Nine Mile Point  
Nuclear Station

***Subject: Application for Amendment to the Technical Specifications Concerning  
the Safety Limit Minimum Critical Power Ratio – Response to Request  
for Additional Information***

**Responses to NRC Request for Additional Information (RAI)  
Documented in NRC Letter Dated January 17, 2002**

Figure 1 Cycle 8 Reference Core Loading Pattern

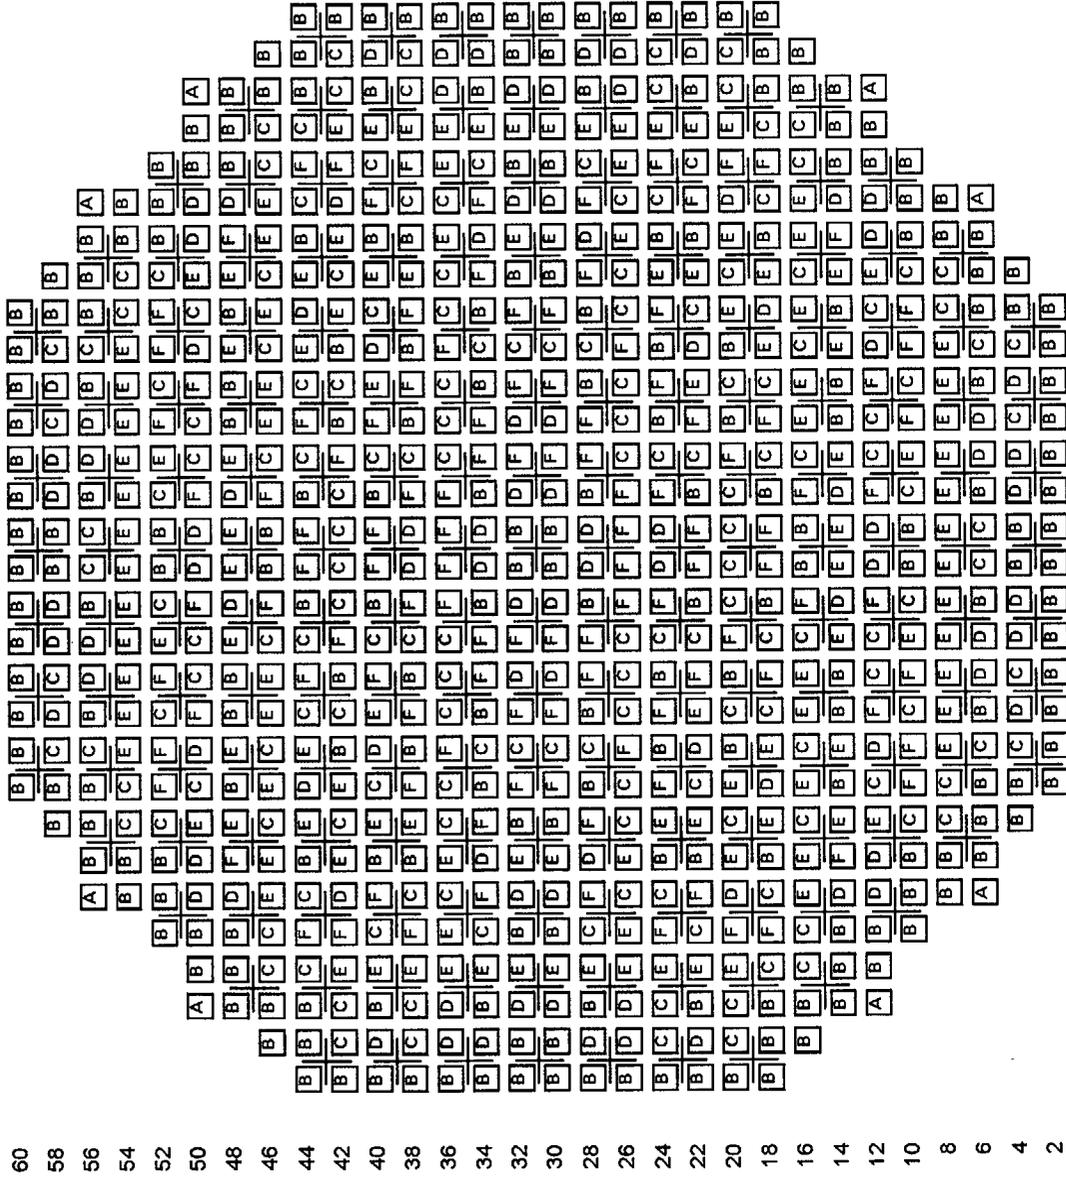
*Provide information on the reference core loading pattern for Cycle 8 and Cycle 9, including bundle name, number in core, and identification of cycle loaded.*

The reference core loading patterns for Nine Mile Point Unit 2 (NMP2) Cycle 8 and Cycle 9 operation are provided in Figure 1 and Figure 2, respectively. The figures also identify the fuel type, cycle loaded, and number in core for Cycle 8 and Cycle 9.

Figure 2 Cycle 9 Reference Core Loading Pattern

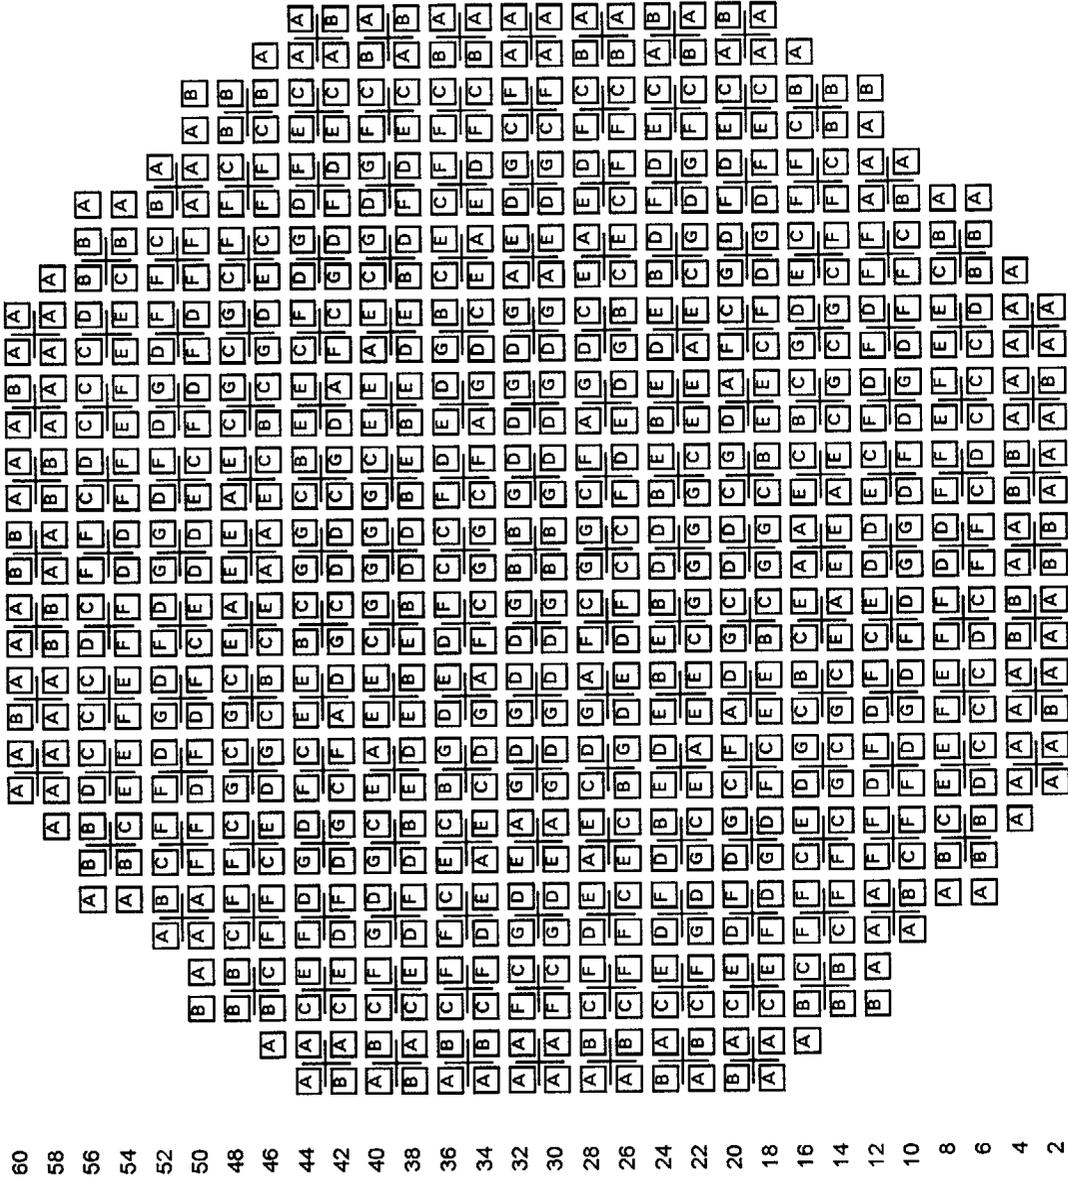
*Describe the difference between the reference core loading pattern for the amendment calculation and the real core loading pattern. Also, describe the procedure to deal with the difference if it occurs.*

At the current time there are no differences between the reference core loading pattern for Cycle 9 and the planned loading pattern. However, because the reload licensing process requires an assumption as to the condition of the core at the end of the previous cycle, it is possible that the as-loaded Cycle 9 core may not be identical to the reference core.
